### *© A319/A320/A321* SERVICE BULLETIN

TITLE : PLACARDS AND MARKINGS - GENERAL - INTRODUCE MODIFIED FIN PLACARDS FOR THE

**OUTFLOW VALVE**

SERVICE BULLETIN NO: A320-21-1096

Figure 1

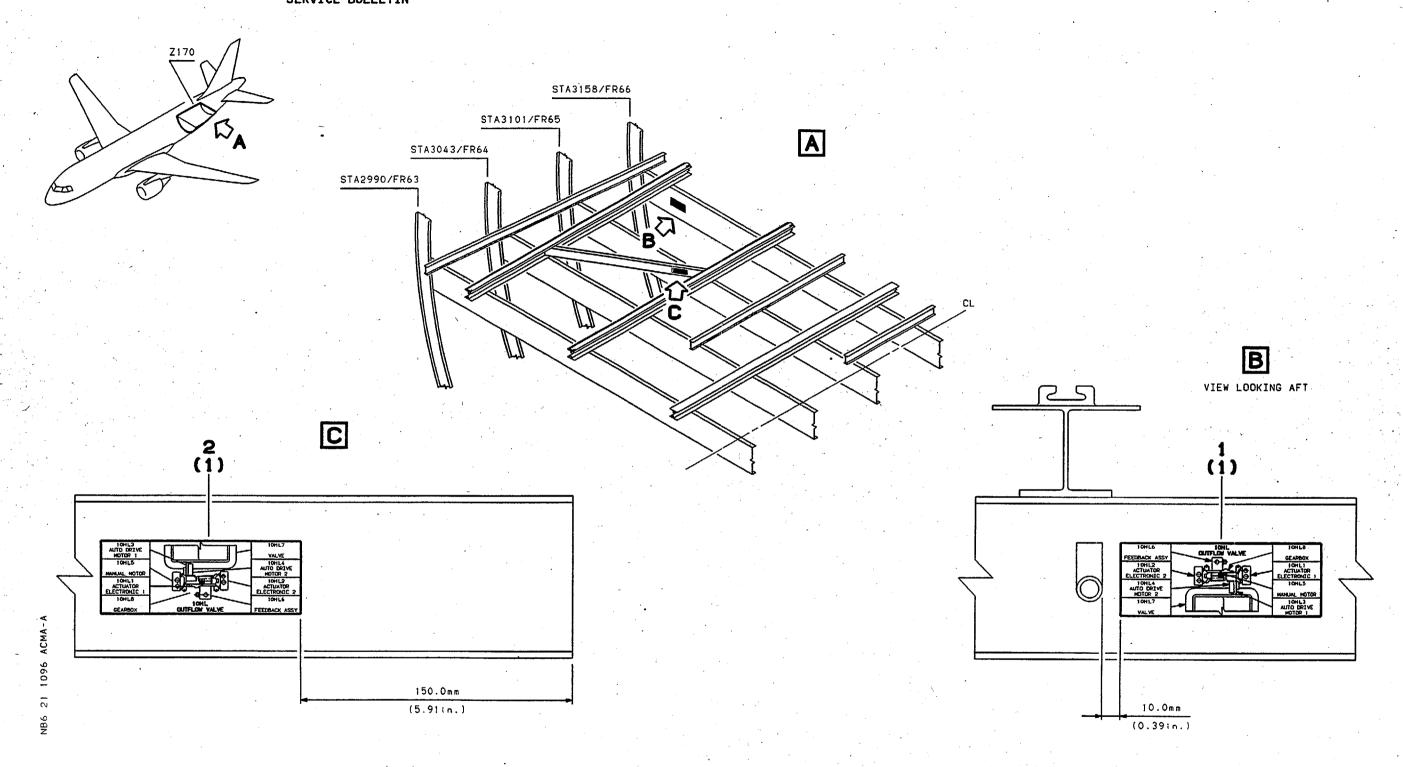
- (1) Install modified FIN placards adjacent to the Outflow valves.
  - (a) Remove and discard this item:

2 placards

D21276001280

(b) Use adhesive (Mat. No. 08-051) to install, as shown in Detail B:

1 placard

D21276001282

(c) Use adhesive (Mat. No. 08-051) to install, as shown in Detail C:

1 placard

D21276001284

item 2

NOTE For A/C that have optional equipment installed, which makes the installation and/or reading of the placard difficult, you can install the new placard in an area of approximately 510 mm (20 in.) adjacent to the outflow valve. You must remove the existing placard or make it unreadable.
